**GUAM WATERWORKS AUTHORITY**

Groundwater Wells A-02, A-07, A-12, D-05 and F-03 Rehabilitation  
GWA Project No. W16-001-EPA  
IFB-01-ENG-2020  
GWA RFI Response No. 1

This Addendum and/or Response to Request for Information (RFI) is issued to modify the previously issued bid documents and/or given for informational purposes and to the extent the responses below modify the bid documents, please treat them as an amendment to the Bid. The following responses are in response to RFIs received.

**SOUNDING TUBE BRACKET**  
SCALE: NONE

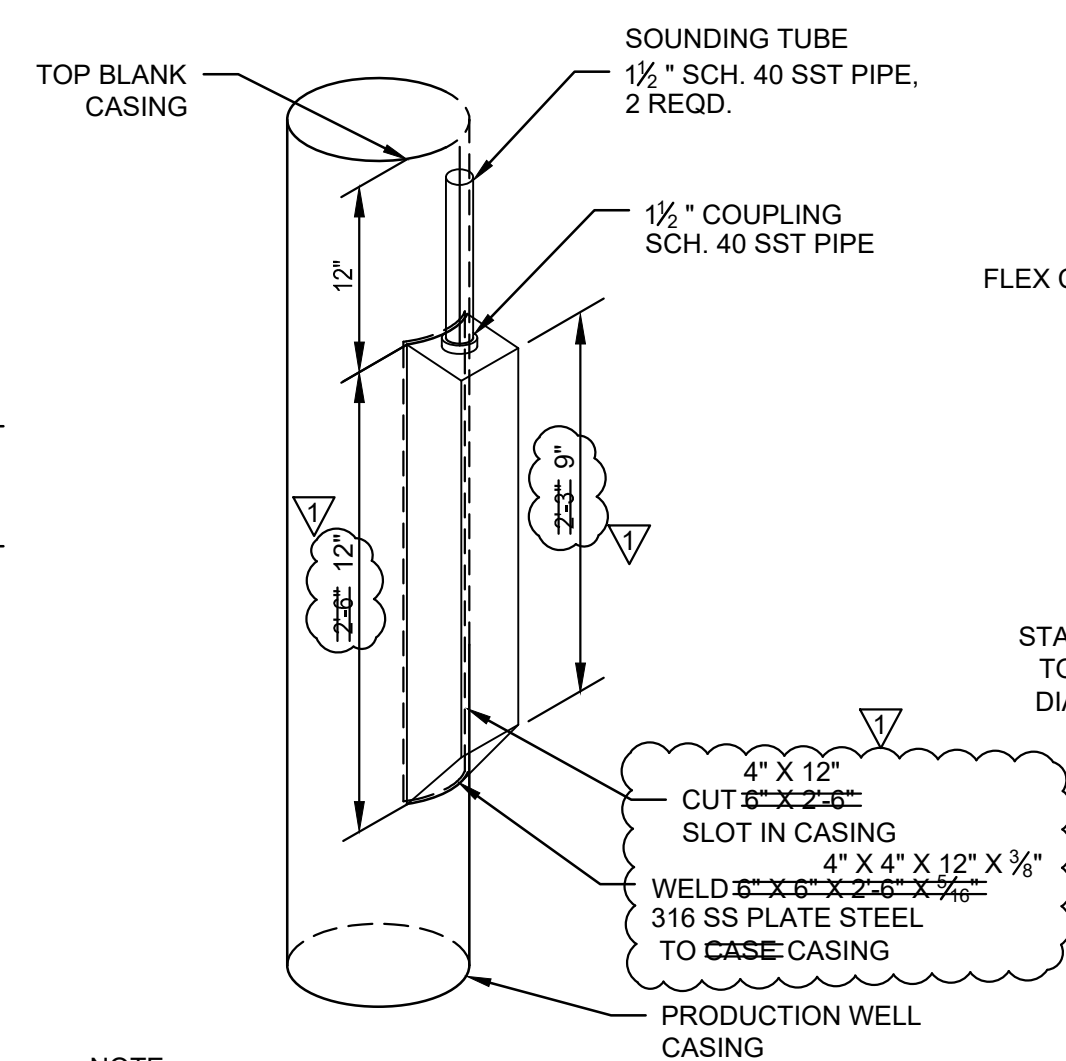
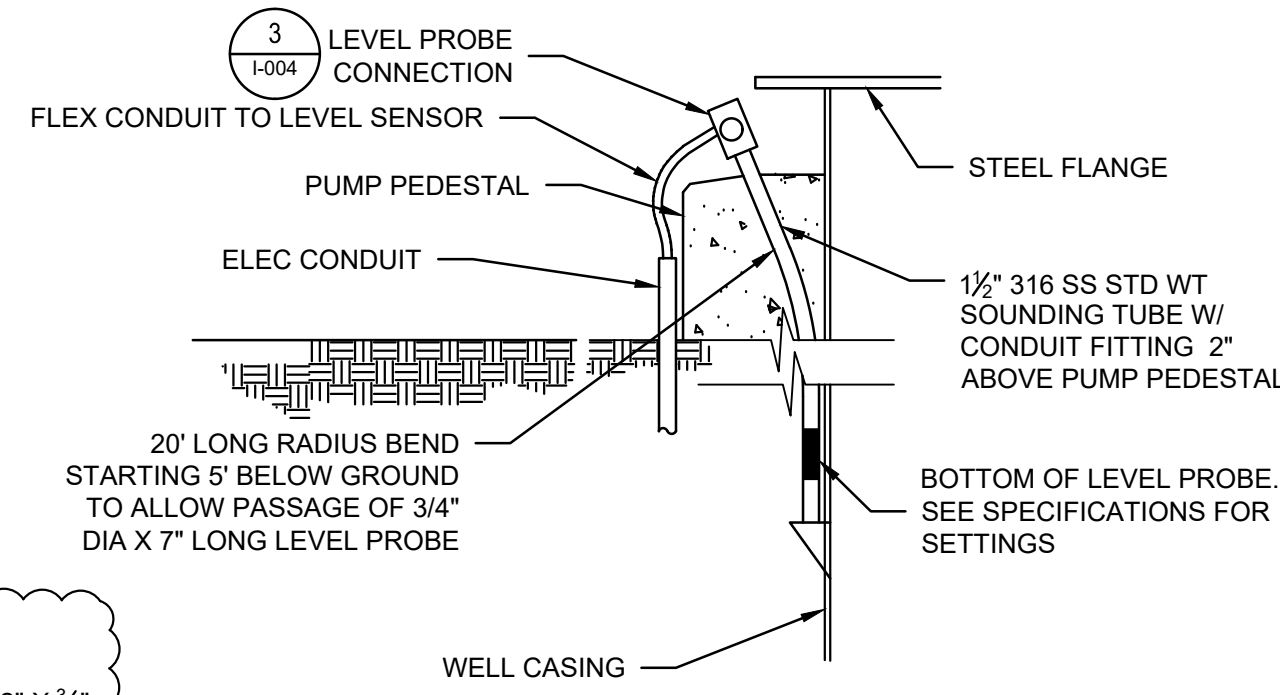
#	Date	Proposer Question	GWA Response
1	11/26/2019	Drawing C-301 shows a 24" diameter borehole with a 14" ID (~14.625" OD) casing. Drawing C-303 shows 2 sounding tubes oriented at 135 degrees apart. The sounding tube insertion boxes at the bottom of the screen protrude out 6", essentially making the diameter of the downhole appurtenances 26.625". Additionally, with 2 sounding tubes and 1 gravel tube on the outside of the casing it will be nearly impossible to measure the gravel pack, well seal and grout without getting the measuring equipment stuck. And also a good chance the sounding/gravel tubes will get damaged (crushed/pinched) during casing installation no matter what size the casing/borehole is. Will GWA provide a new design and extend the RFI submittal time?	<ul style="list-style-type: none"> <li>a. For a nominal 14" ID well casing, the OD is 14.5". See DWG No. C-303_rev1, the sounding tube bracket dimensions have been revised from (6" x 6" x 2'-6" x5/16") to (4" x 4" x 12" x 3/8"). The effective diameter of the downhole appurtenances is 21.7".</li> <li>b. Requirement of two sounding tubes is a design requirement requested by GWA. The means and methods of the measurement is the Contractor's responsibility.</li> <li>c. The bracket will be of the same material and thickness as the well casing and can be rounded at the bottom to reduce the potential of being damaged. Contractor shall take precaution during installation to prevent damage of the well casing materials.</li> <li>d. DWG No. C-303_rev1 has been revised to reduce the dimensions of the sounding tube bracket.</li> <li>e. No extension to the RFI period is provided.</li> </ul>
